# Technical Note

## Great Cauldham Park, Capel Le Ferne

18-027-009 Rev -

Technical Note in response to KCC Consultation

Drawing Title  
**Surface Water Catchment Plan**

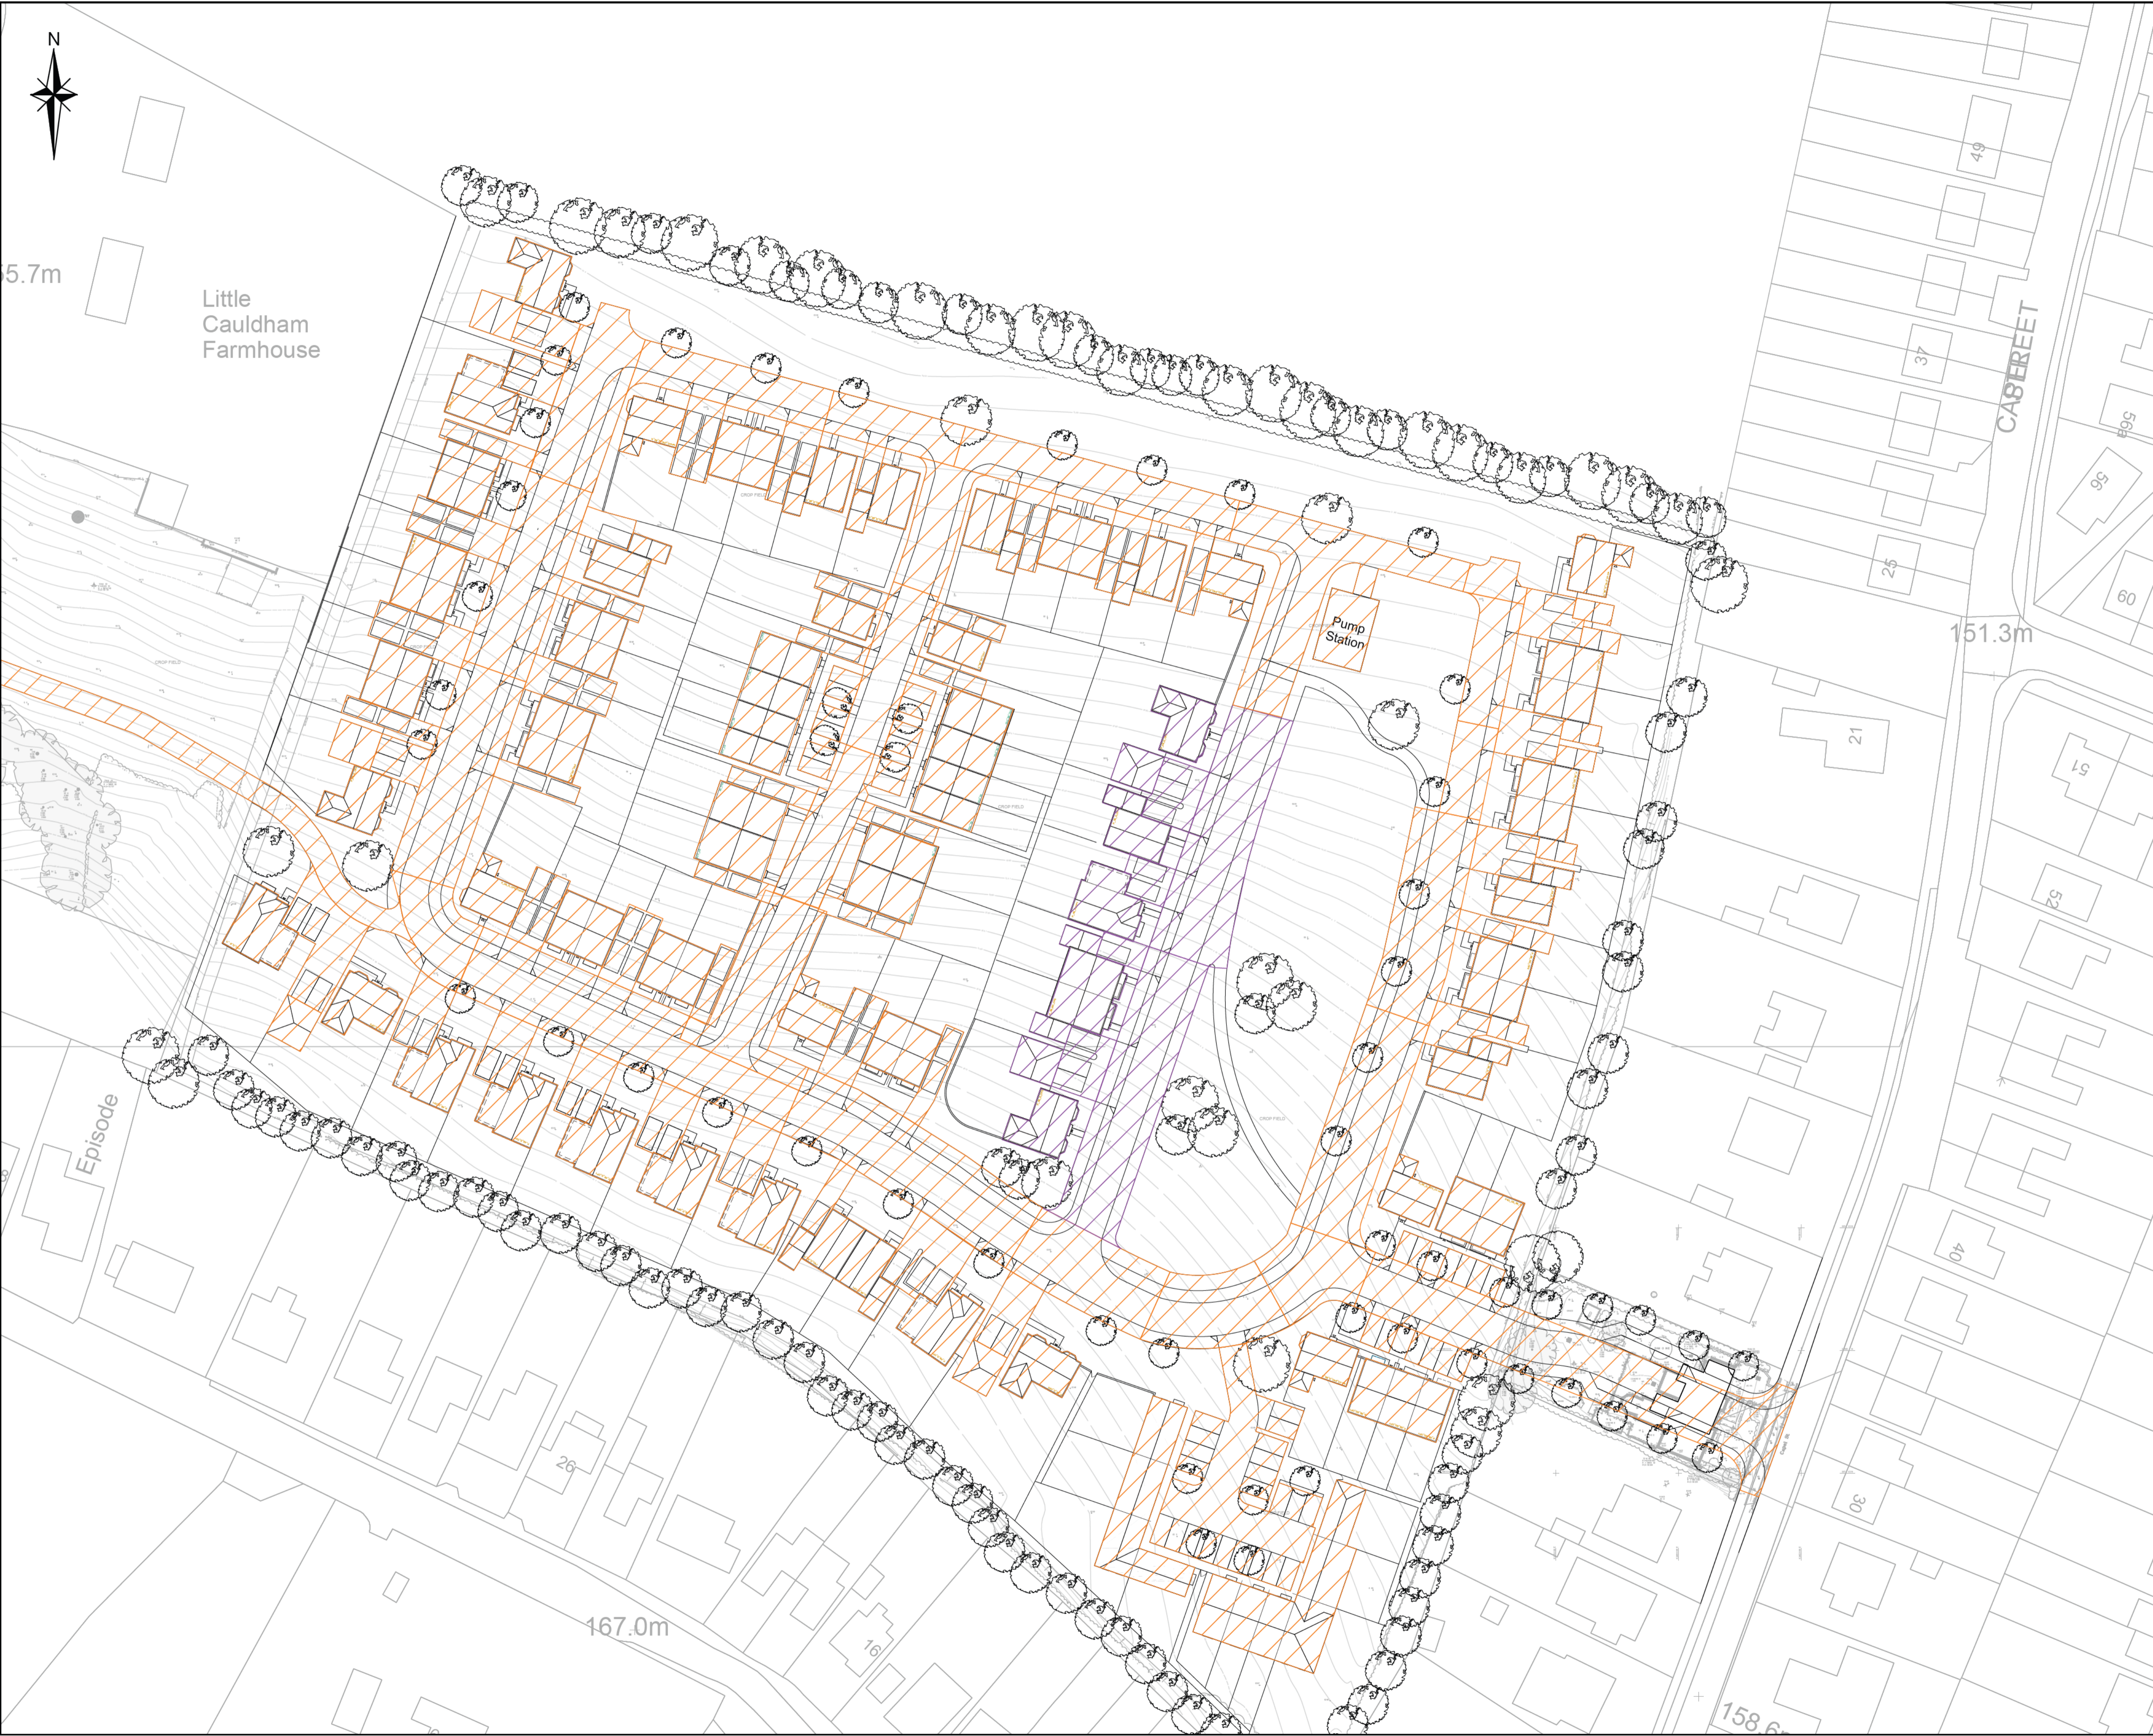
*"Whilst no areas are specifically mentioned within the body of the Flood Risk Assessment provided we note that various areas are quoted throughout the Ecologia report contained within appendix C - 4.03Ha on pg 54 of the FRA, 4.55Ha on pg 60, etc and that the application form details 4.55Ha. None of these areas reflect that used within the contained hydraulic calculations, given the nature of the superficial layer here (impermeable clay) we would expect for all pluvial water to have to be positively drained from site and so would request for information to be provided regarding the site areas used in the calculations and for a catchment plan denoted by receiving network to be provided."*

2.1.3 However, the proposed surface water strategy has been designed to collect surface water runoff from the hard standing areas of the proposed development. This equates to an area of 1.937 Ha. The site area is 4.05 Ha therefore, the proposals will be collecting and discharging to ground 47.8% of the existing catchment. This will significantly reduce the surface water flood risk to the surrounding area.

2.1.5 Full Network calculations have been provided in **3.1.1 Appendix B**. The calculations show the catchments draining to each node. These catchments have been measured using the Site Layout. A catchment plan has been provided in **3.1.1 Appendix C**, that can be read in conjunction with the calculations.
